RE: PLANAPP 2024-00990 – Opal Ridge - Team Review Reply #1

On behalf of Opal Ridge Suites GP Limited, please find attached our detailed reply to the Team Review Letter of July 17h. We have replied in a similar table format as the original letter and added a column with our responses (Attachment A). Further to Attachment A, a revised site plan has been provided which outlines the removal of the east-west walkway connection from Blocks C and G to Park P-2.

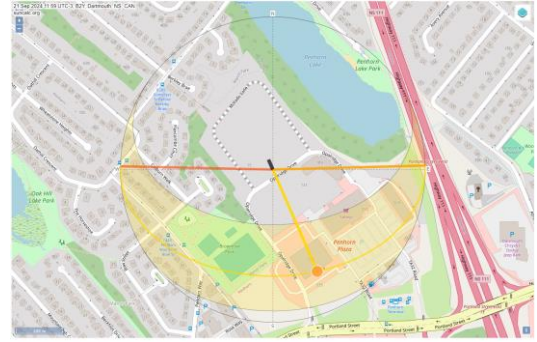
| <p>Parkland Planning</p> | <p>3) The Regional Centre Secondary Municipal Planning Strategy, Part 2.9.1.2 Penhorn Mall Lands, Policy F-9 states:</p> <p>“When considering a development agreement for the Penhorn Lands Future Growth Node, Council shall consider Policy F-6 and the following:</p> <p style="padding-left: 40px;">ii) transitioning the height of new development down to existing low-rise residential buildings and public parks,”</p> <p>Reducing the building setback from the shared property from 6.0 m to 3.0 m will significantly alter this transition to the adjacent parkland by placing the public and private uses in closer proximity increasing</p> | <p>3) While the reduction in the setback is technically significant specifically in that it is a 50 percent reduction in the proposed setback, in terms of impact there will not be a significant change on the impacts to the building residents or the functionality of the park. The policy, in relation to other policies, requires the consideration of the uniqueness of the site and design, and with that consideration, our original discussion regarding the reduced setback provides a balanced and appropriate discussion of the issue.</p> <p>As discussed in our submission, the useability of the park is not anticipated to be impacted in any significant way as the solar orientation of the park allows solar access for the majority of the day with the sun rising on the Penhorn Lake side and setting on the Brownlow Park side with the path of the sun running to the south of the building.</p> |

Further, the reciprocal impacts of a reduced setback are minimal. Parkland planning outlined that noise and emissions were examples of a concern. With regard to emissions, we do not understand this concern. Neither the proposed multi-unit dwelling or the multiple use trail are a significant source of emissions.

From a noise perspective, we do not anticipate that either land use will be a significant source of noise. Noise emitted from the building are similar to any other multiple unit residential building and multi-unit dwellings facing the park are not significant and mostly resident related noise from units or balconies and typical of the urban environment. Noise emitted from park users would be similar.

As previously indicated impacts are expected to be minor at best. Further when the proposal is looked at with all policies, the proposed design and building relationships provide a better implementation of the overall intent of policy (tight urban form). Further from a functional perspective the two uses complement each other.

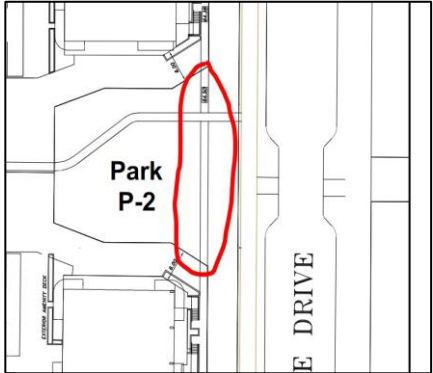
| <p>Planning / Project Lead</p> | <p>6) The Block G & Block C site plan submitted includes a pathway to provide pedestrian access to the dwelling unit entrances facing Opalridge Drive (shown below). The pathway crosses through the parcel (PID 41537762) required to be conveyed as municipal parkland. This pathway is not shown in the plans approved in the original development agreement and should not be constructed on the parkland parcel. Please revise plans to remove the pathway.</p> <p>If this is a request to HRM Parkland Planning to add a pathway across the lands, please revise your written submission to clarify.</p>  | <p>6) The walkway shown has been removed and a revised illustration provided.</p> |
